Gravity Probe B Relativity Mission

GSS Requirements Verification Analysis Report 1

S0451 Rev. A

7 January 2003

GSS Aft Control Unit (ACU) Block Diagram

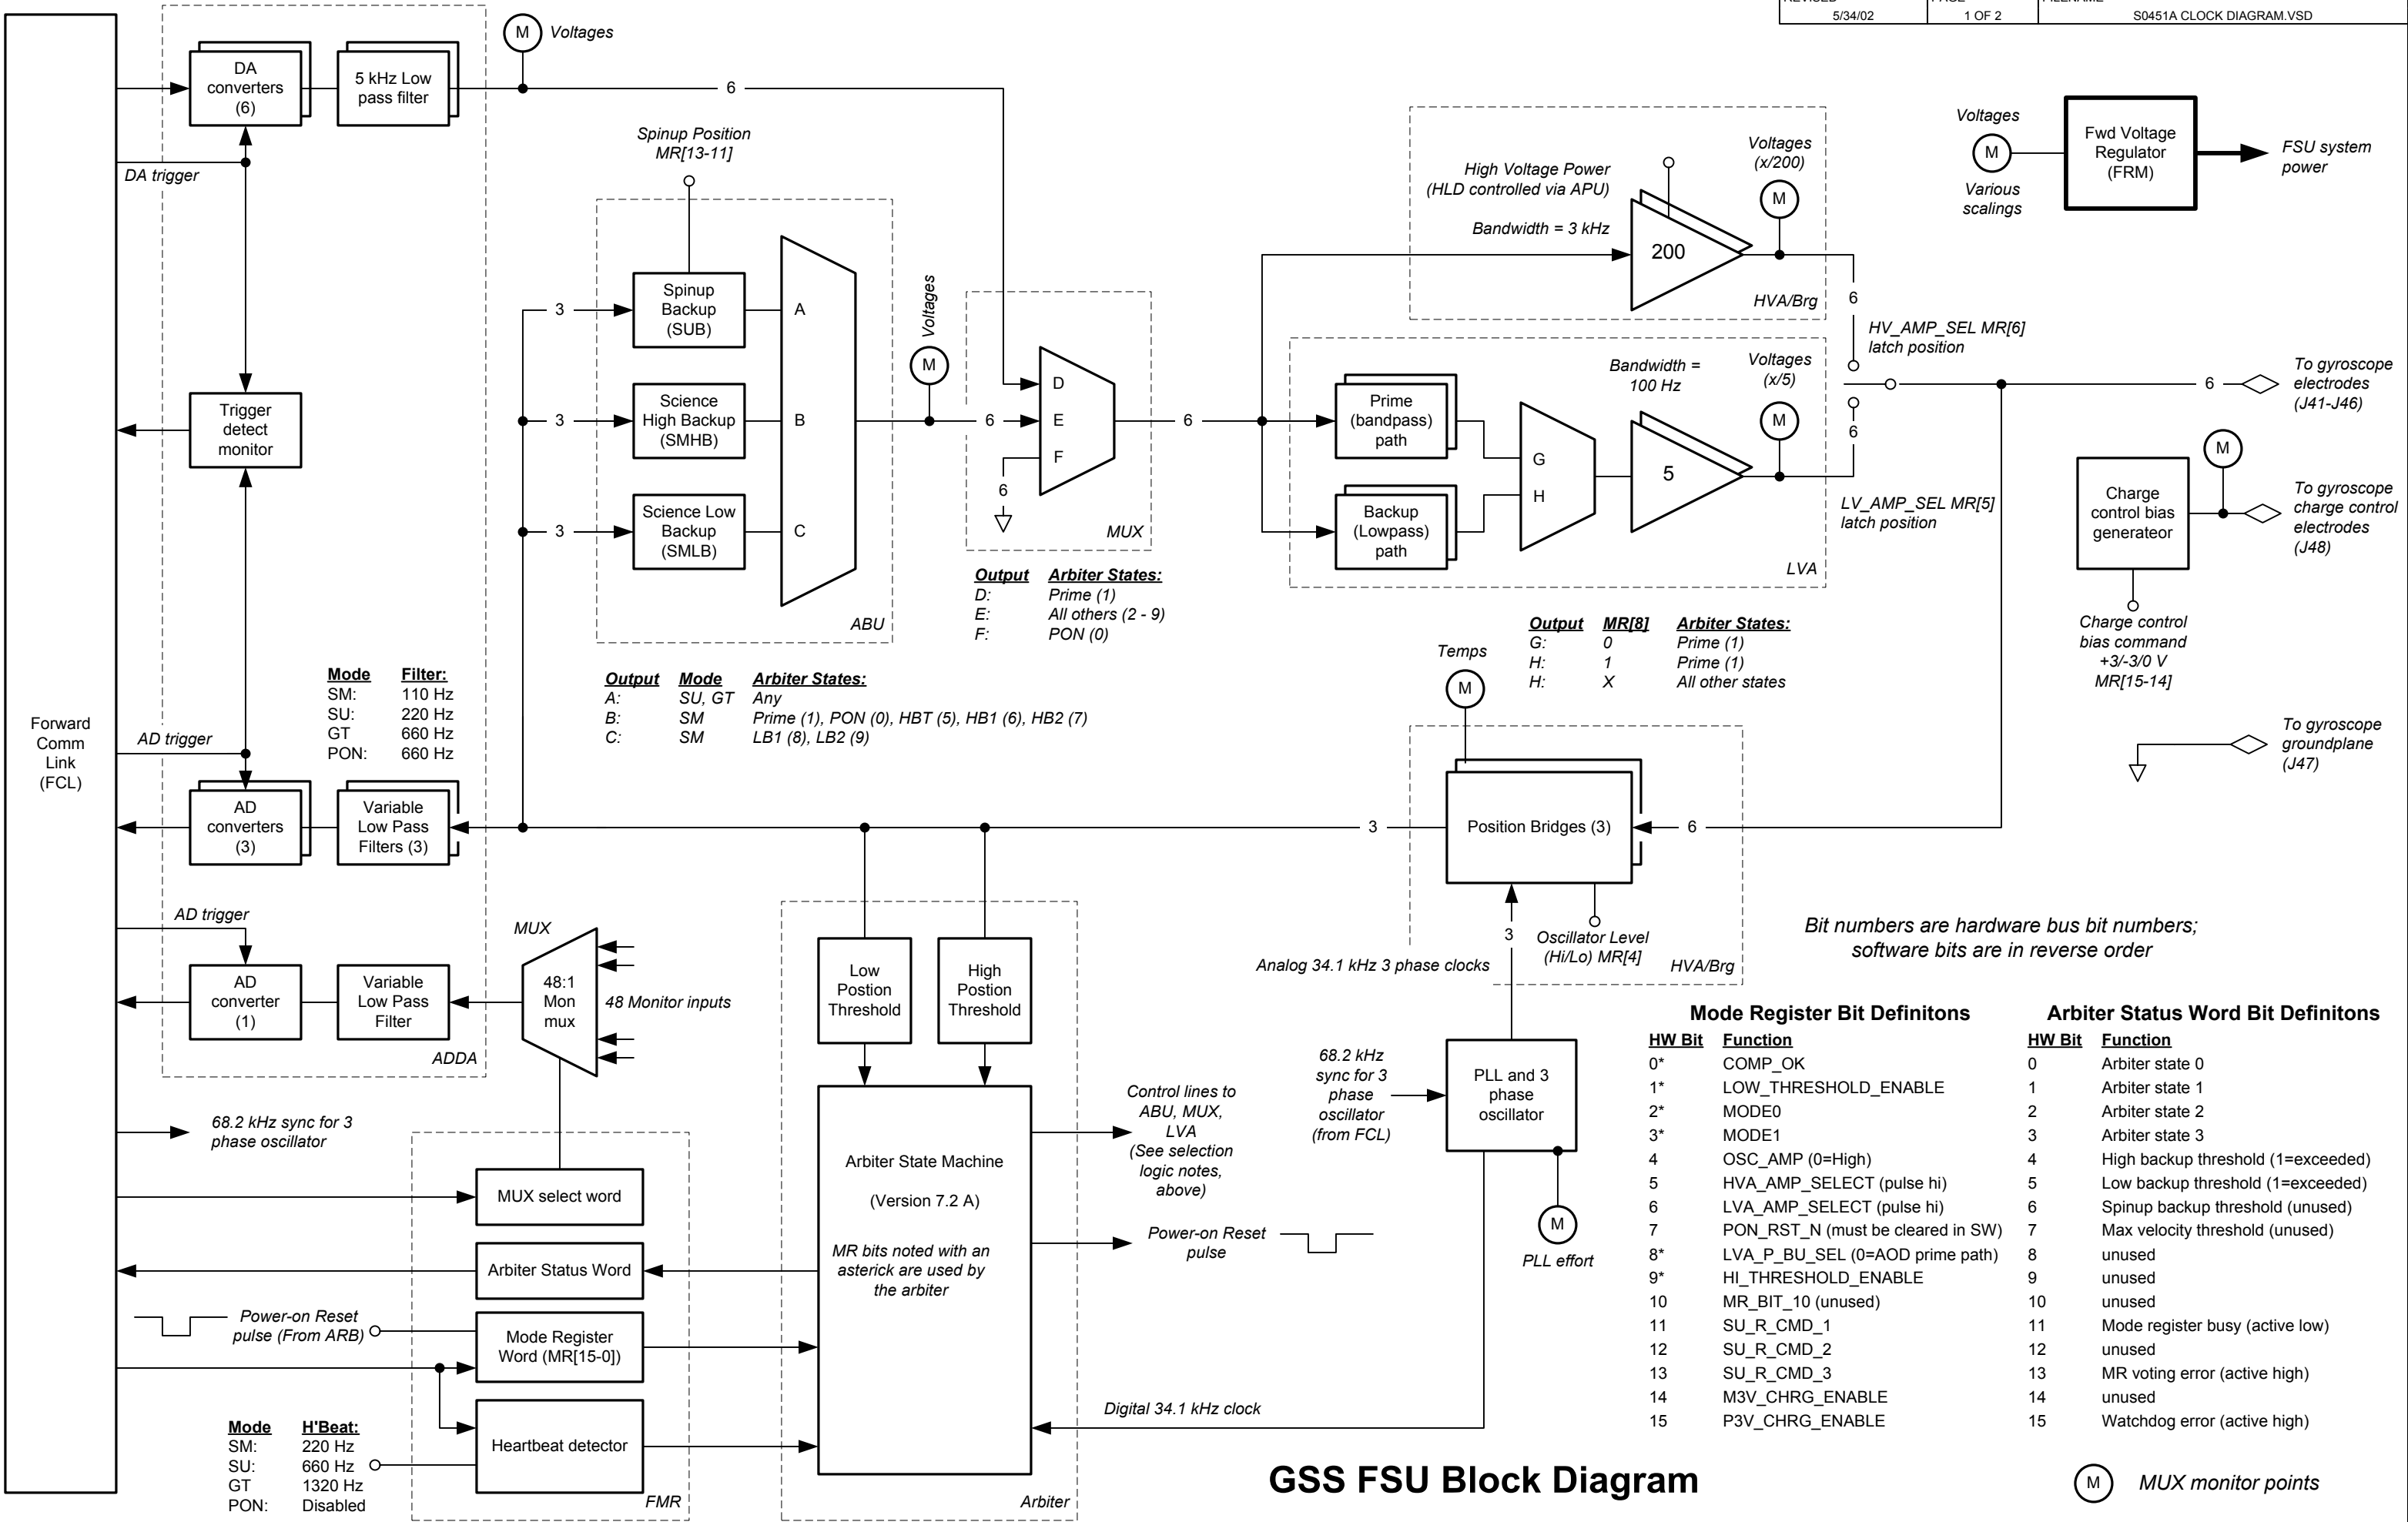
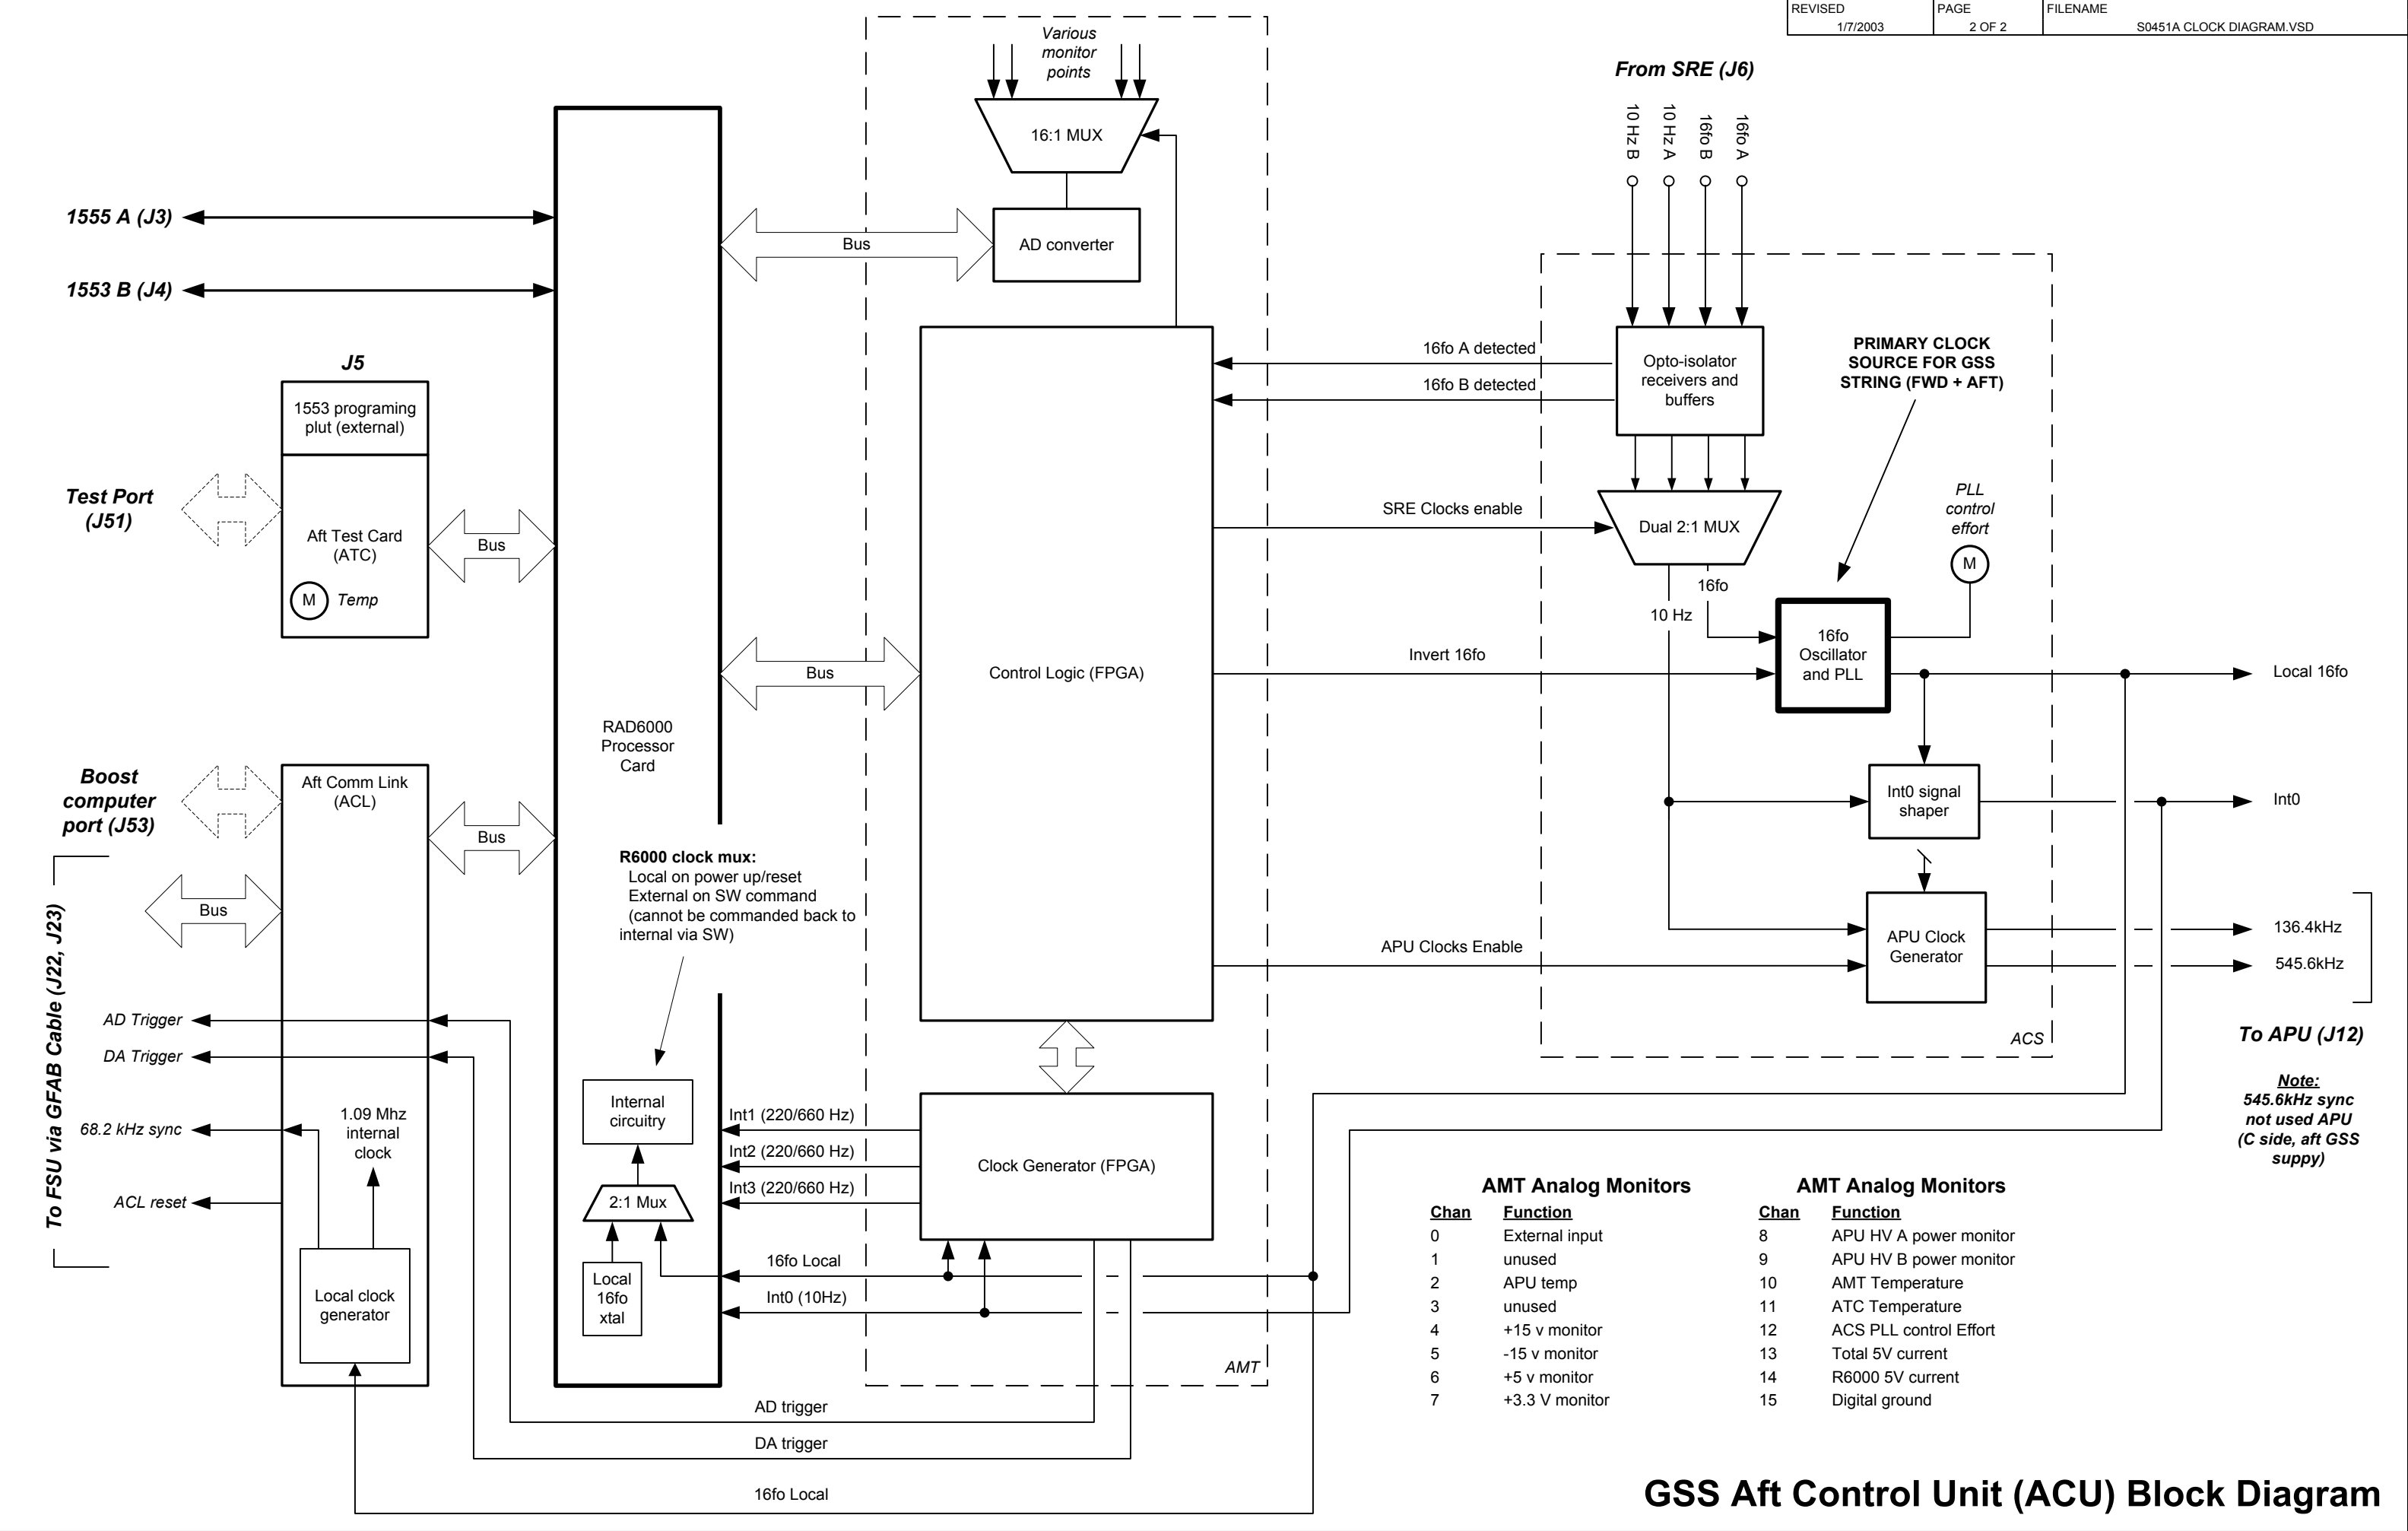
- 2) *Update S0451 regarding the analysis of the GSS ASU APU Timing Signal and the GSS ASU AMT Timing Signal.*

Attached two page block diagram of aft and forward GSS boxes that show the generation and routing of the GSS clocks.
